**ALLEN & MAJOR
ASSOCIATES, INC.**

DRAINAGE REPORT

PROFESSIONAL ENGINEER FOR ALLEN & MAJOR ASSOCIATES, INC.

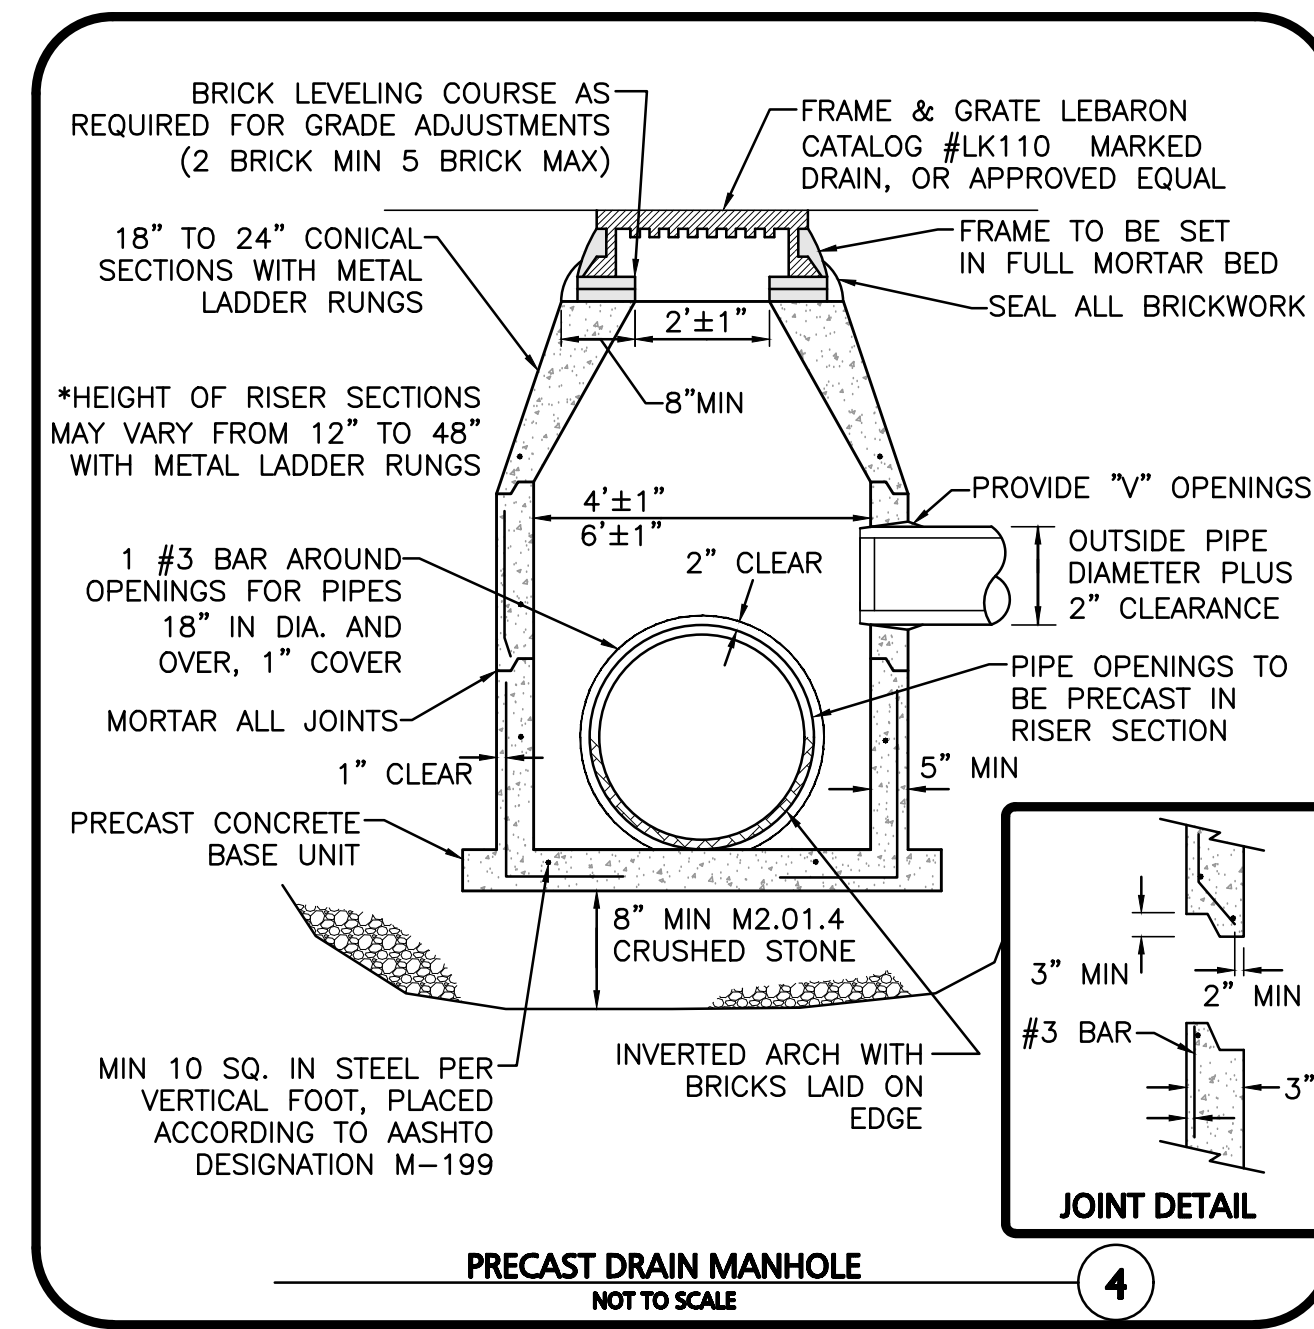
REV	DATE	DESCRIPTION
B	3/25/2024	REVISED PER TOWN COMMENTS
A	2/29/2024	REVISED PER TOWN COMMENTS

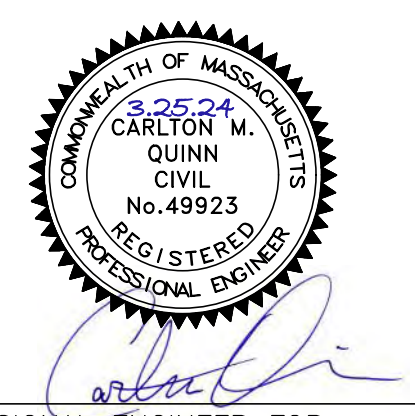
REV	DATE	DESCRIPTION
B	3/25/2024	REVISED PER TOWN COMMENTS
A	2/29/2024	REVISED PER TOWN COMMENTS

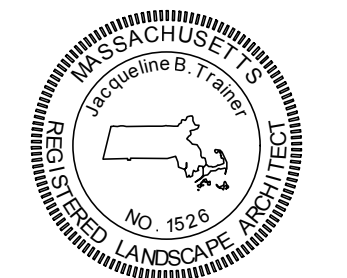
REV	DATE	DESCRIPTION
B	3/25/2024	REVISED PER TOWN COMMENTS
A	2/29/2024	REVISED PER TOWN COMMENTS

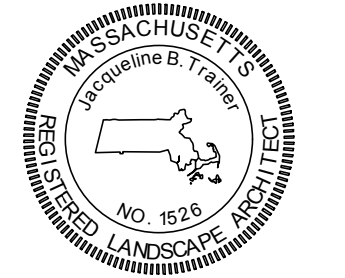
REV	DATE	DESCRIPTION
B	3/25/2024	REVISED PER TOWN COMMENTS
A	2/29/2024	REVISED PER TOWN COMMENTS
